Marin Headlands and Fort Baker Transportation Infrastructure and Management Plan

Final Environmental Impact Statement

March 2009

Final Environmental Impact Statement Marin Headlands and Fort Baker Transportation Infrastructure and Management Plan

FIGURE 2.3 ALTERNATIVE 3 (PREFERRED ALTERNATIVE) — ENHANCED MULTI-MODAL ACCESS (ROADS, PARKING, AND TRANSIT IMPROVEMENTS)

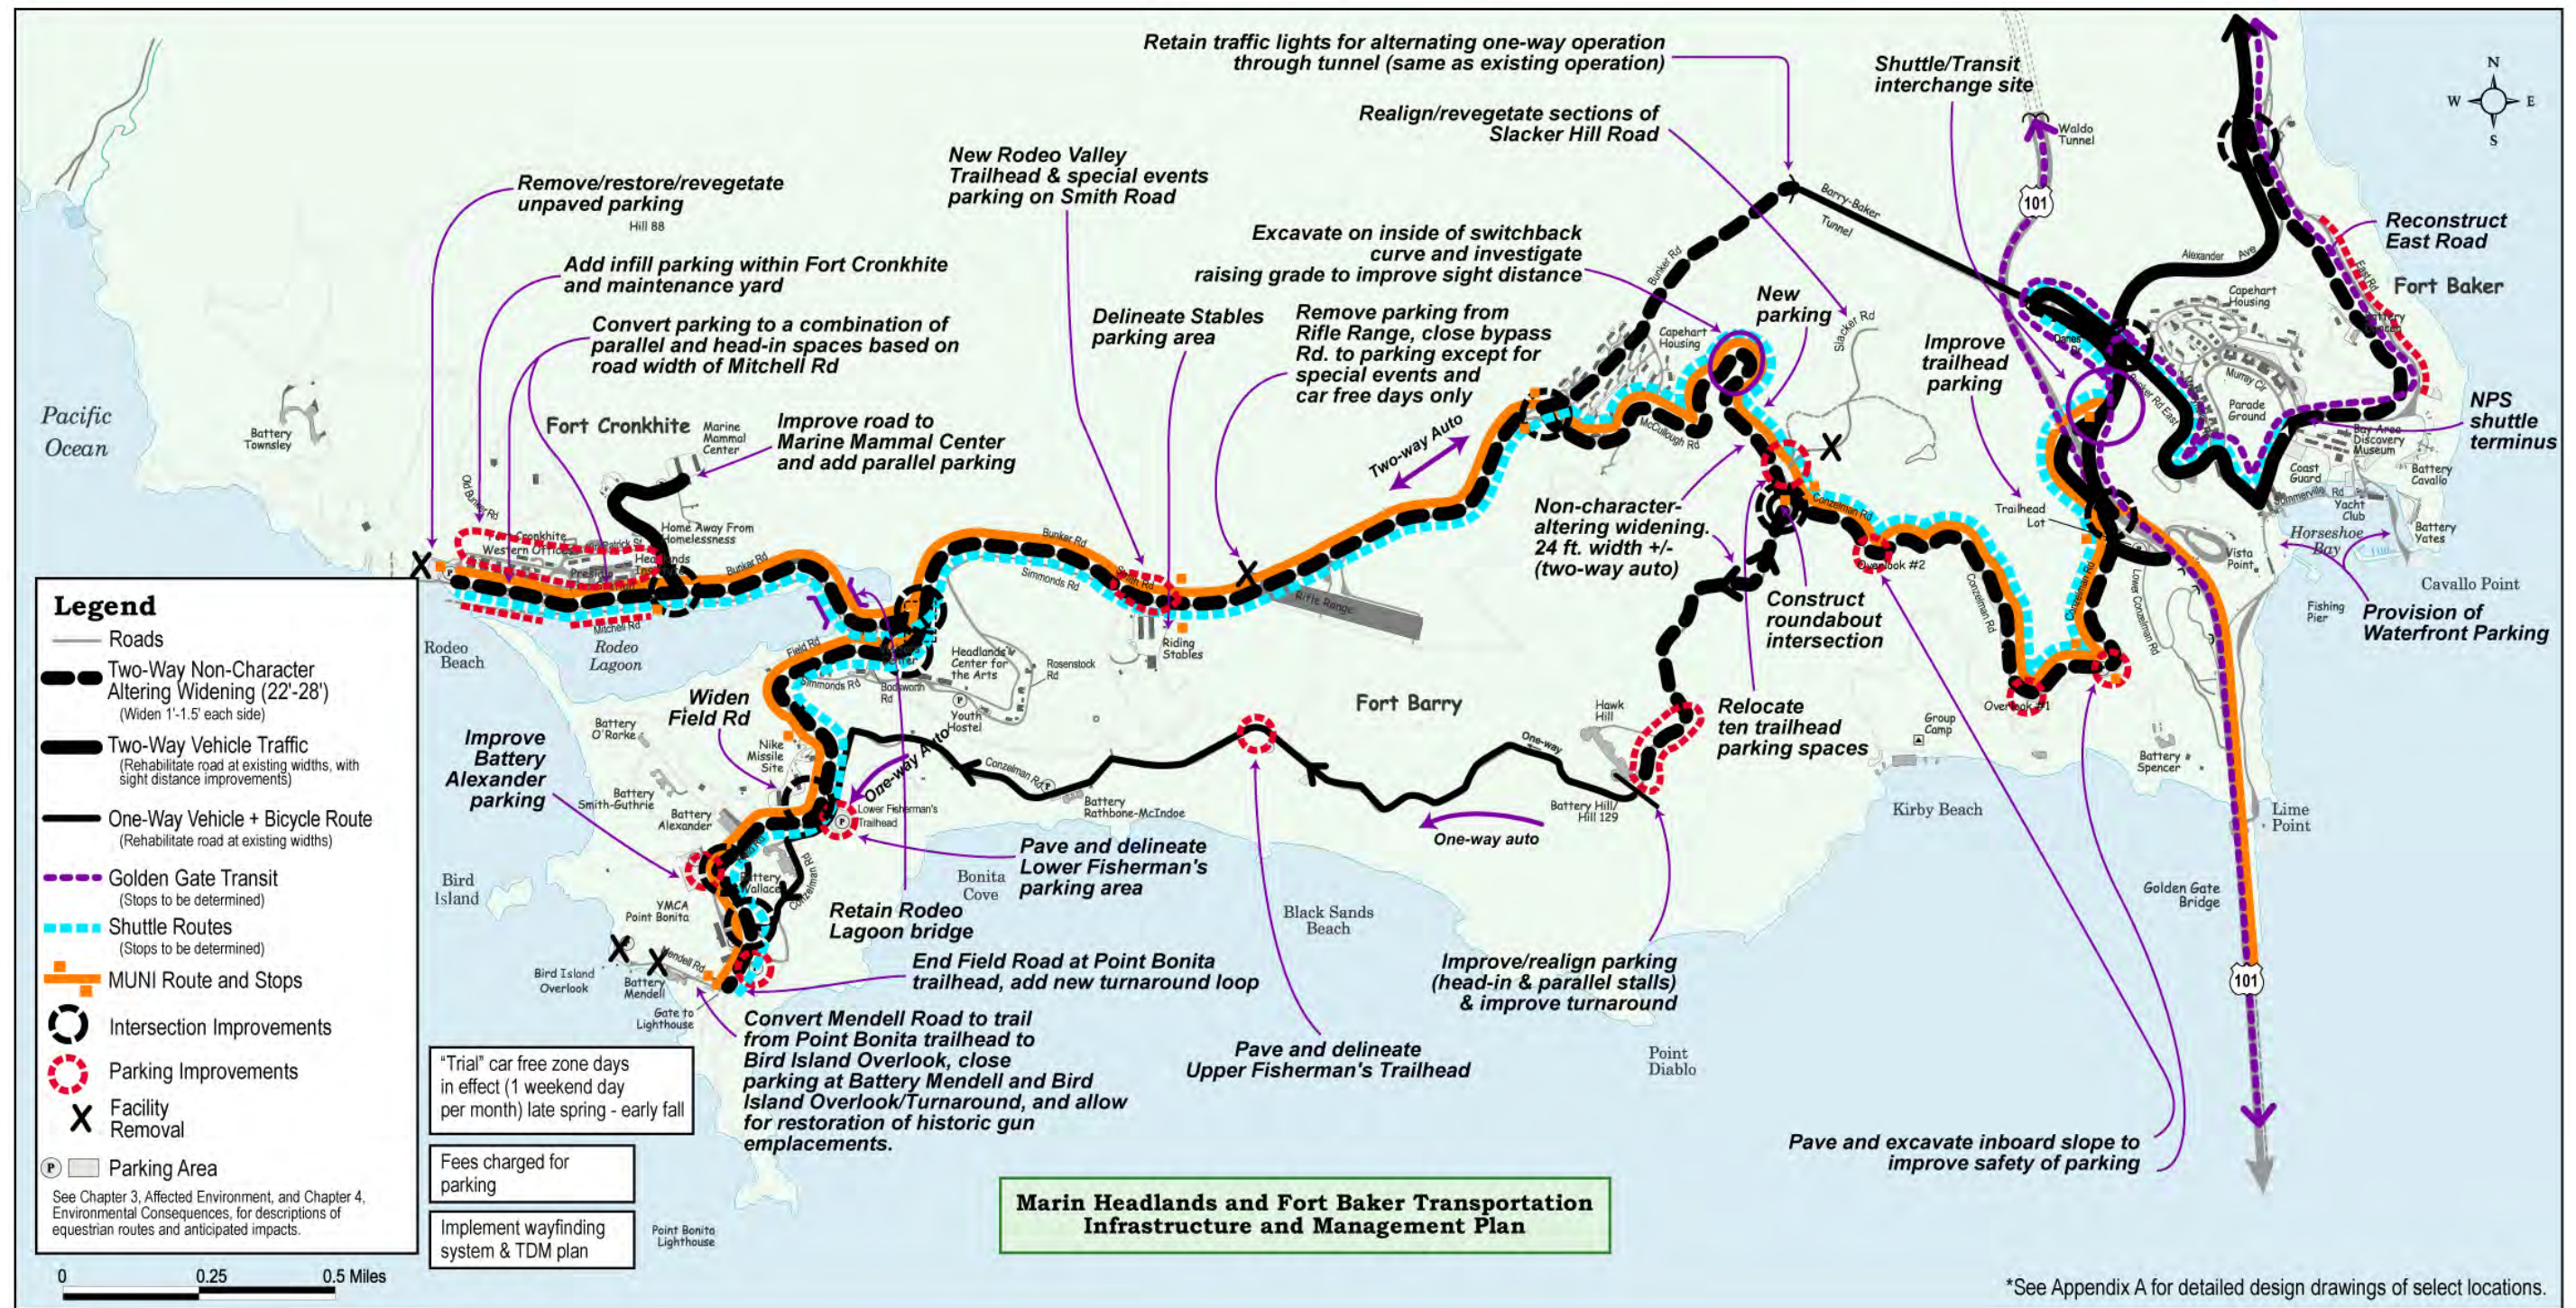
1. Section 2.5.5 describes Alternative 3 transit services and states that GGT Route 10 service on Alexander Avenue would continue with connections to other transit services at bus stops on the east and west sides of Highway 101 and with pedestrian/bicycle access at Danes Drive. However, Figure 2.3 and Table 2.1 show GGT operating on Bunker Road and East Road into Fort Baker. Further, it is not clear how connections between GGT and other services would be enabled at Highway 101 since GGT currently does not have a bus stop near Hwy. 101 in the southbound direction due to roadway conditions, and pedestrian access between the west and east sides of Highway 101 is constrained by the narrow underpass. Table 2.1 Summary of Alternatives, page 65, identifies bus stop and underpass improvements as future projects in Alternative 1 – the no-action alternative. District seeks clarification on how such apparently necessary improvements to GGNRA can be part of a no-action alternative.

In alternative 3, NPS would encourage the GGT Route 10 on Alexander Avenue to be rerouted to provide direct service to Fort Baker. Section 2.5.5 of the FEIS will be clarified for consistency with Figure 2.3 and Table 2.1, which show GGT operating on Bunker Road and East Road to provide service to Fort Baker.

- Response:** In Alternative 3, the GGT Route 10 on Alexander Avenue would be rerouted to provide direct service to the main post area of Fort Baker. Section 2.5.5 of the FEIS will be clarified for consistency with Figure 2.3 and Table 2.1, which

FIGURE 2.6 ALTERNATIVE 2 — BASIC MULTI-MODAL ACCESS (ROADS, PARKING, AND TRANSIT IMPROVEMENTS)

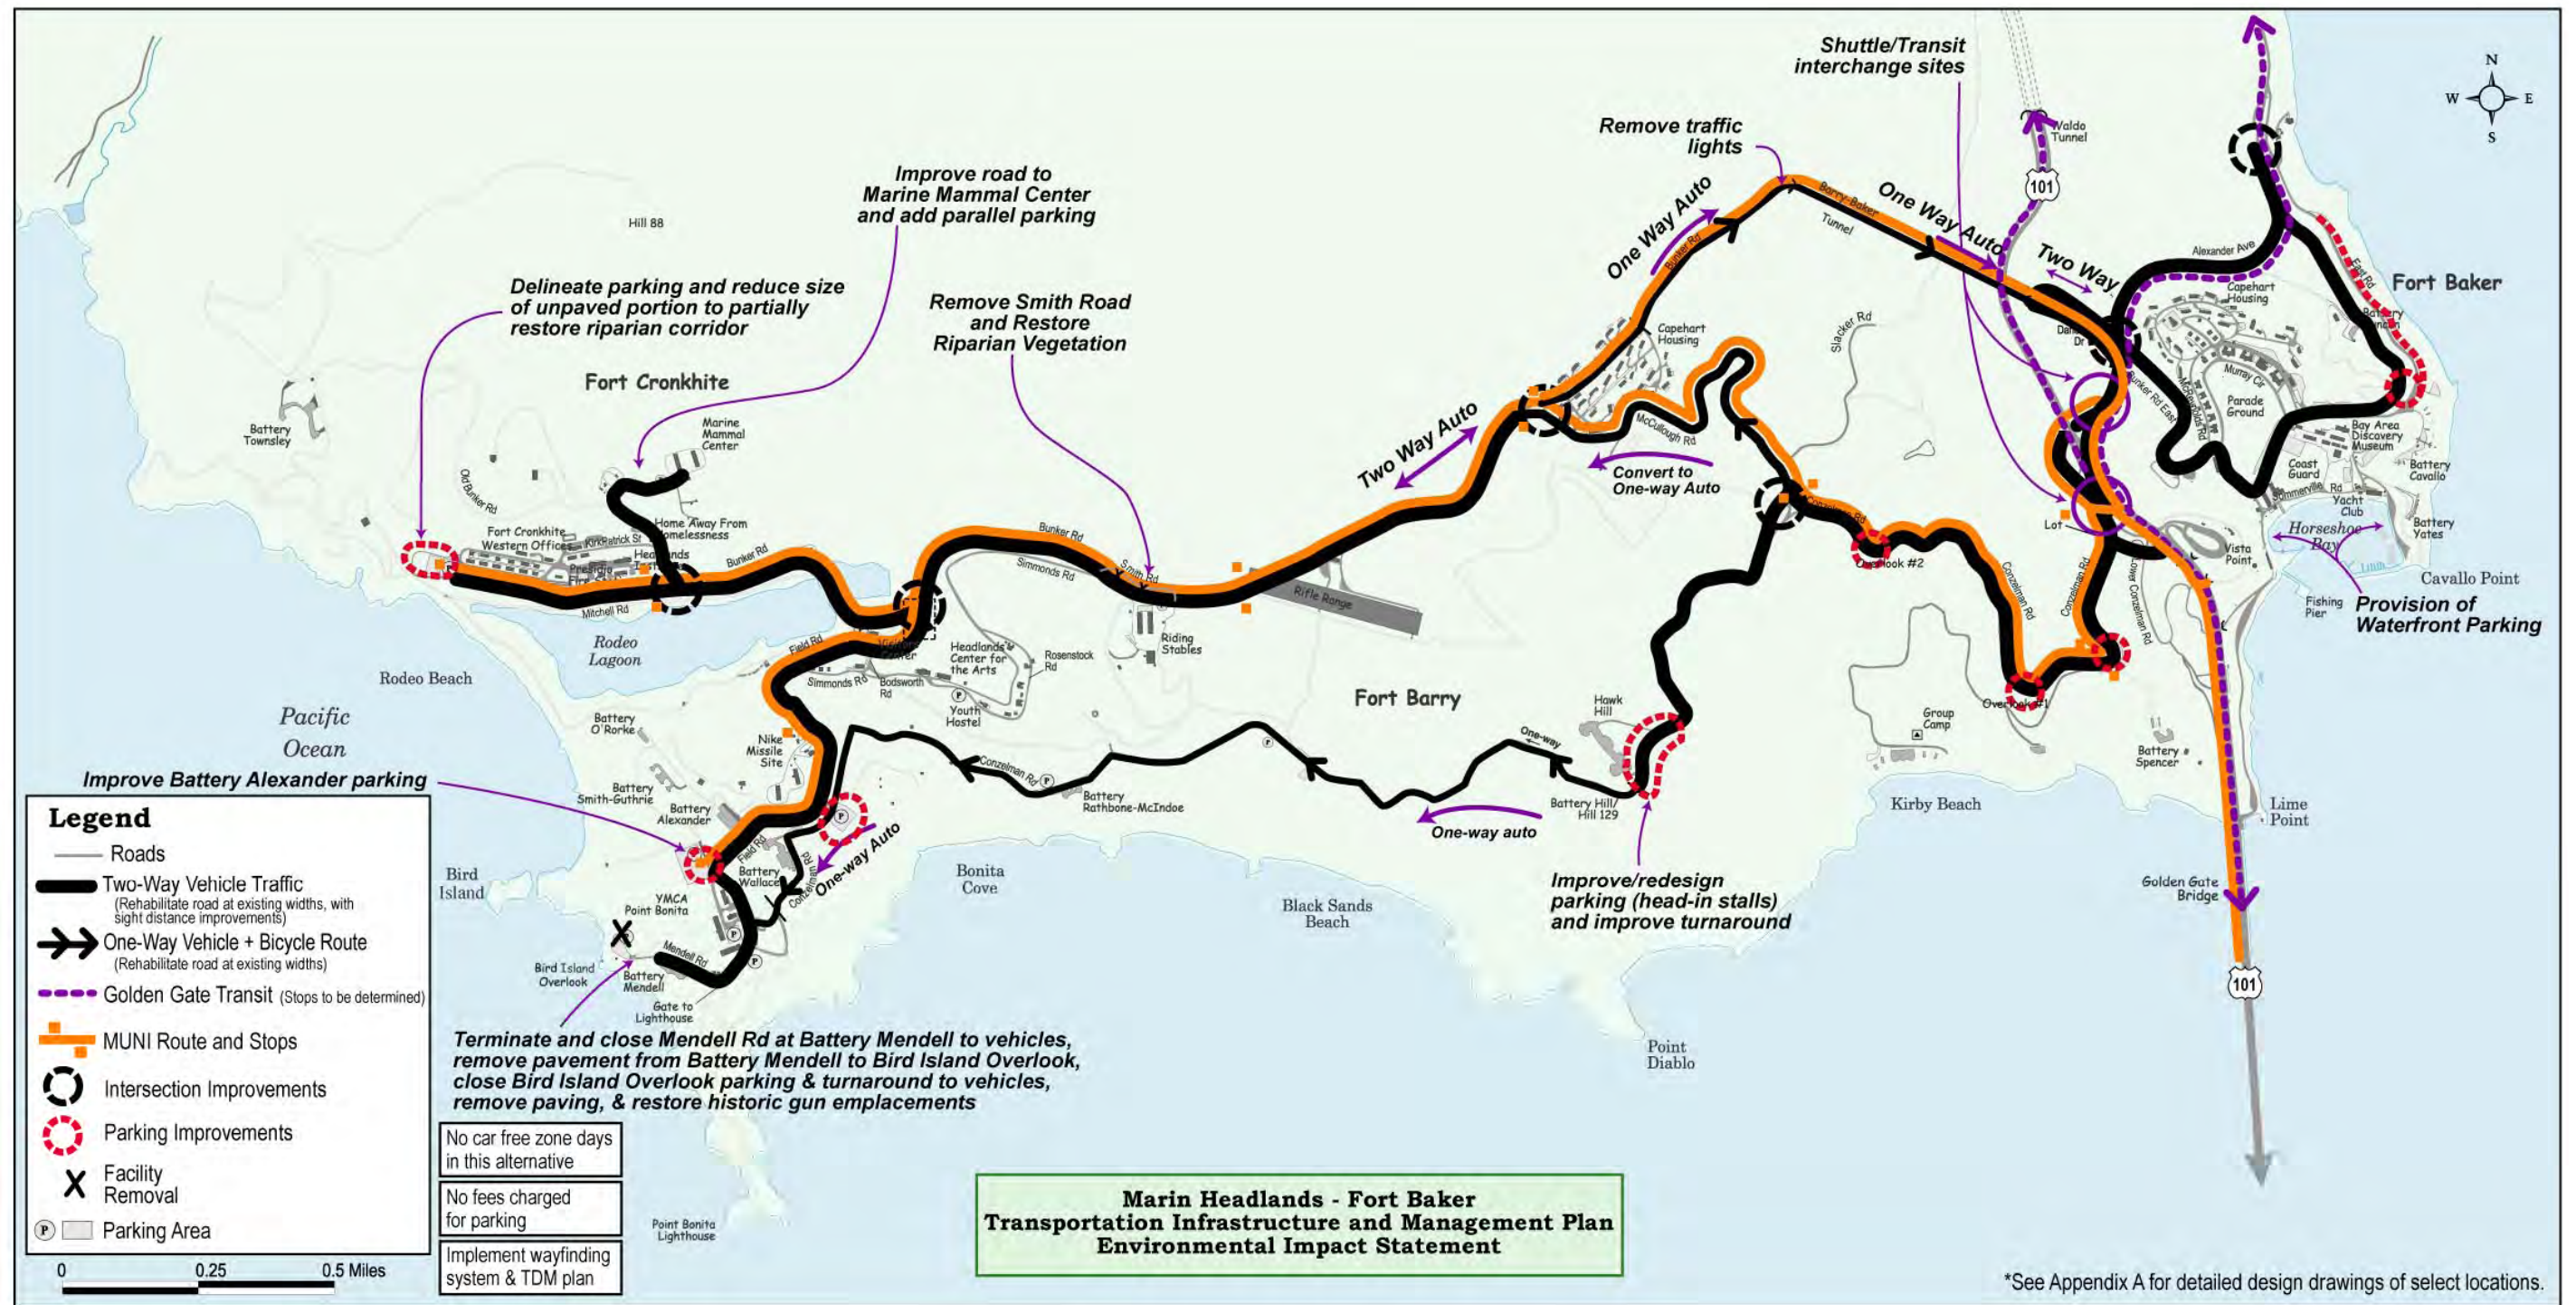
2. Section 2.6.5 describes Alternative 2 transit services. Figure 2.6 also shows the Highway 101 transit connection locations described in Section 2.5.5 and we reiterate our related comment above.

CONCERN STATEMENT: Section 2.6.5 describes Alternative 2 transit services. Figure 2.6 also shows the Highway 101 transit connection locations described in Section 2.5.5 and we reiterate our related comment above.

Response: In Alternative 3, the GGT Route 10 on Alexander Avenue would be rerouted to provide direct service to the main post area of Fort Baker. Section 2.5.5 of the FEIS will be clarified for consistency with Figure 2.3 and Table 2.1, which show GGT operating on Bunker Road and East Road to provide service to the main post area.

FIGURE 2.8 ALTERNATIVE 4 — MAXIMUM MULTI-MODAL ACCESS (ROADS, PARKING, AND TRANSIT IMPROVEMENTS)

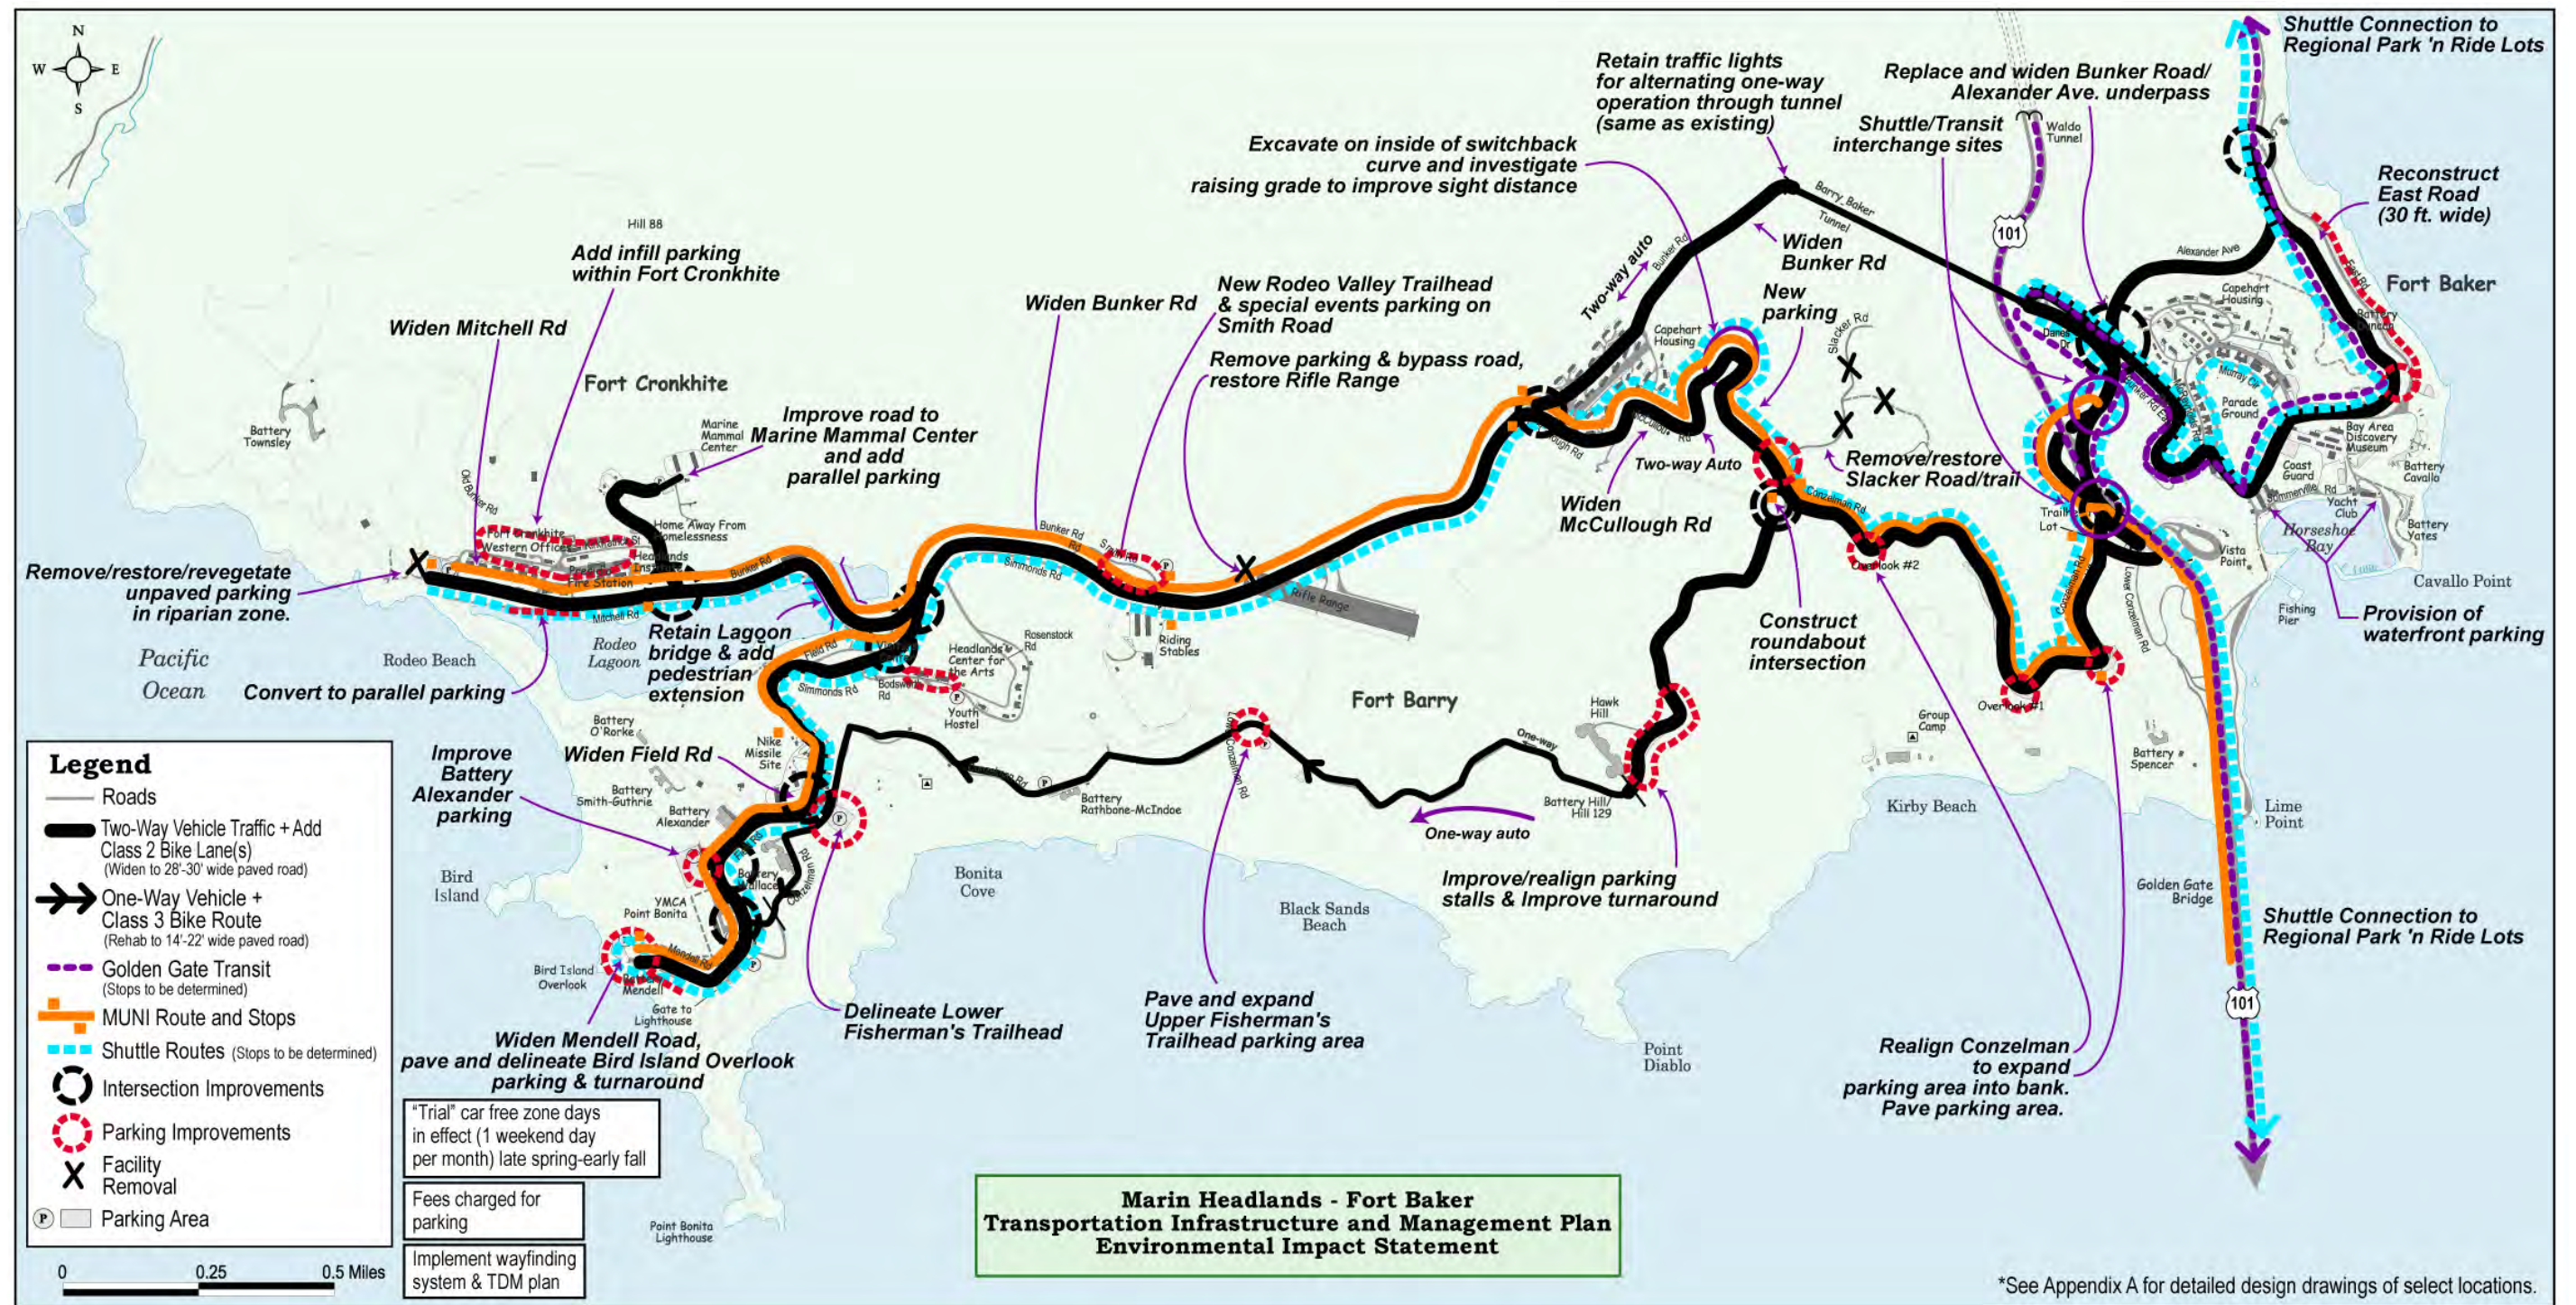
3. Section 2.7.5 describes Alternative 4 transit services. Figure 2.8 shows GGT operating on Bunker Road and East Road into Fort Baker. District staff had previously informed GGNRA staff and consultants of need for roadway improvements, such as wide lanes and standard bus stops, to accommodate GGT bus operations and bus stops at Fort Baker. Please clarify if such improvements are

Section 2.7.5 describes Alternative 4 transit services. Figure 2.8 shows GGT operating on Bunker Road and East Road into Fort Baker. District staff had previously informed GGNRA staff and consultants of need for roadway improvements, such as wide lanes and standard bus stops, to accommodate GGT bus operations and bus stops at Fort Baker. Please clarify if such improvements are included in GGNRA plans. Figure 2.8 also shows the Highway 101 transit connection locations described in Section 2.5.5 and we reiterate our related comment above.
